November 2, 2017

RE: Water Obstruction and Encroachment Applications:

- E06-716: Birdsboro Power, LLC
 - E06-717: DTE Midstream Appalachia, LLC
 - E06-718: Reading Area Water Authority
- Erosion and Sediment Control General Permit
- ESG00011170001, DTE Midstream Appalachia, LLC
- State Water Quality Certification
- WQ03-003. DTE Midstream Appalachia, LLC

Approximate location of proposed 230 kV ring bus substations. Map source: Google Maps

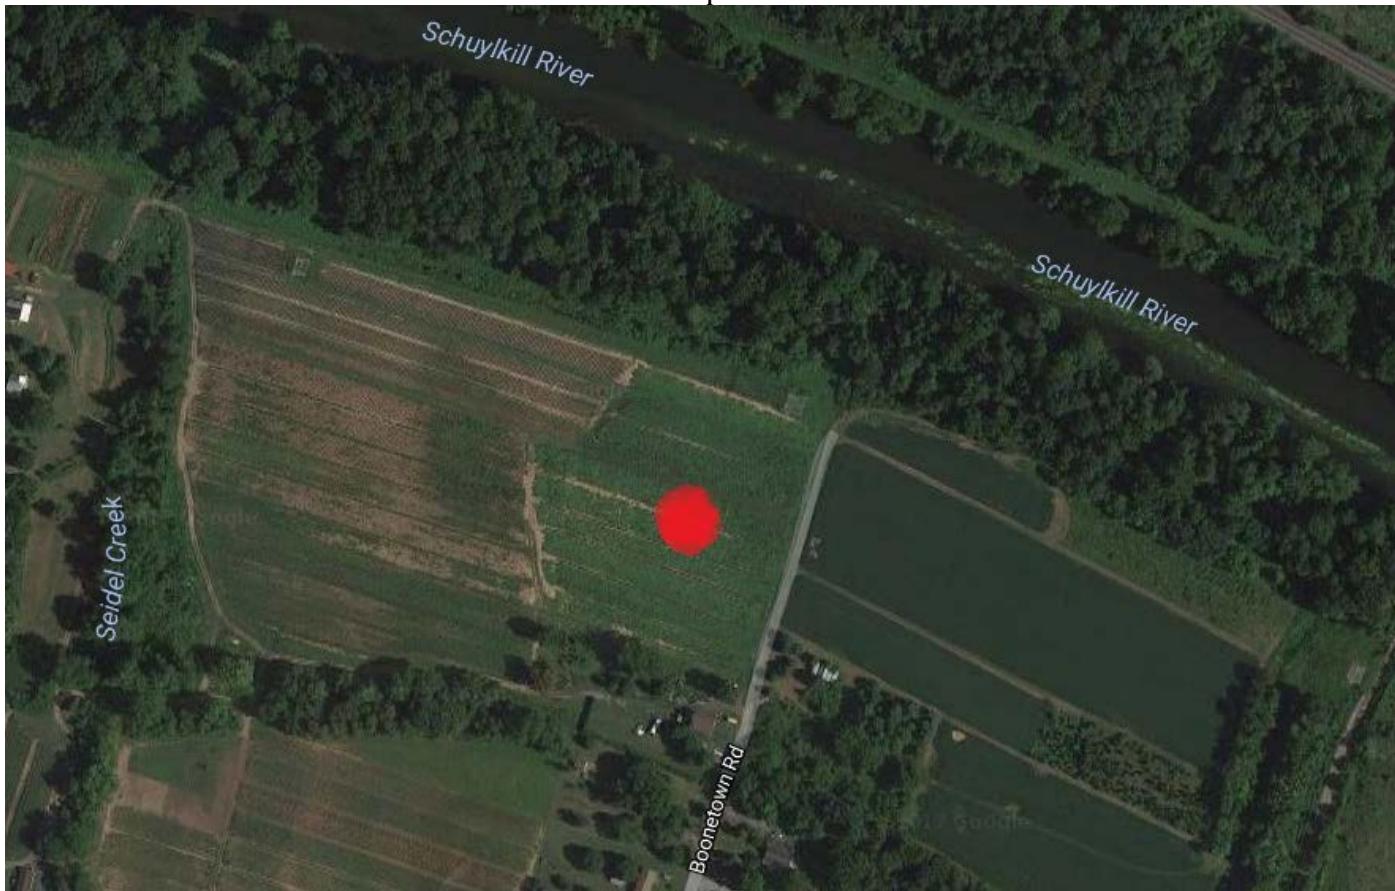
DRN also notes that, similar to DRBC's docket, Birdsboro Power's Chapter 105 application appears to omit important information about the site of the substation, information necessary for permitting. The completed substation is described as occupying approximately 5 acres.¹⁴ However, the proposed impacts to that five acre site are not addressed in the Chapter 105 application. No wetland delineation was undertaken for the five acres site or it was not included in Birdsboro Power's application. The substation site is omitted from the mapping provided in the applicant's Site Specific Plan.

As no photos of the substation have been provided, DRN is providing an image with approximate location for the substation drawn from other descriptions.

The site of the proposed substation, in Robeson Township, is located in both the flood fringe and the flood way. Flooding has been documented as occurring at the site under current land use conditions even without a significant rain event.
